TECHNICAL BULLETIN

INSTALLATION AND REPLACEMENT OF PROTECTIVE SLEEVE (SPEEDI-SLEEVE PN 084956) ON TAIL ROTOR TRANSMISSION OUTPUT GEARSHAFT

All 500D Model 369D Series Helicopters.

Figure 1. Speedi-Sleeve (PN 084956) Installation/Replacement

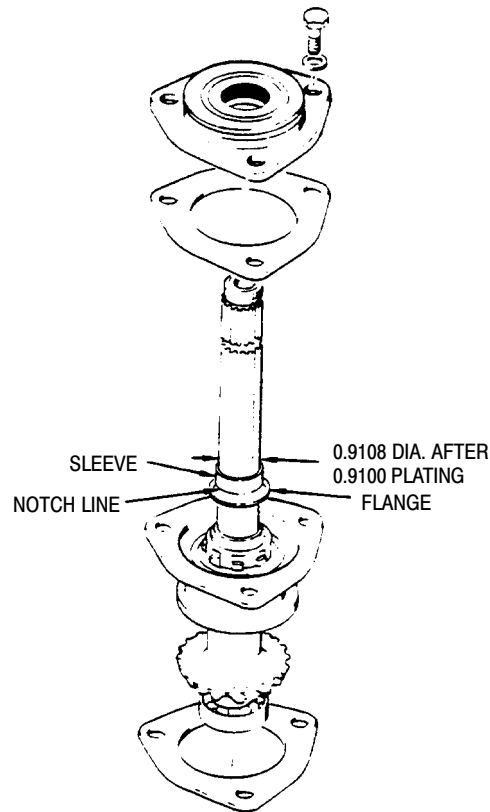
Information given in this Service Information Notice provides procedures for installing and replacing a protective sleeve (Speedi-Sleeve PN 084956) on the, output gearshaft of 369A5400 series tail rotor transmissions. The protective sleeve will prevent gearshaft wear caused by the gearshaft rubbing against the output gearshaft cover oil seal lip. It can also be used to repair minor gearshaft wear caused by the seal rubbing against the shaft.

NOTE: If shaft has been grooved from rubbing against lip of output gearshaft cover seal, and depth of groove exceeds 0.005 inch, shaft must be replaced. (Refer to Part III or VIII, 369D COM.) If groove does not exceed 0.005 inch depth it may be repaired with Devcon A.

- (c). While Devcon A is wet, put sleeve on shaft, flange down, and press or tap in place using 1-inch tube or pipe bottomed on flange of sleeve. The unflanged end of sleeve must be even with outboard end of 0.9100 - 0.9108-inch diameter seal journal. Tap end of pipe with hammer or mallet as necessary to correctly position sleeve on shaft. Wipe any excess Devcon A from shaft using a clean, lint free cloth.
- (d). Clip flange of sleeve to notch line and peel from shaft.

(6). Replace installed sleeve, if damaged or grooved, as follows and as shown in Figure 1.
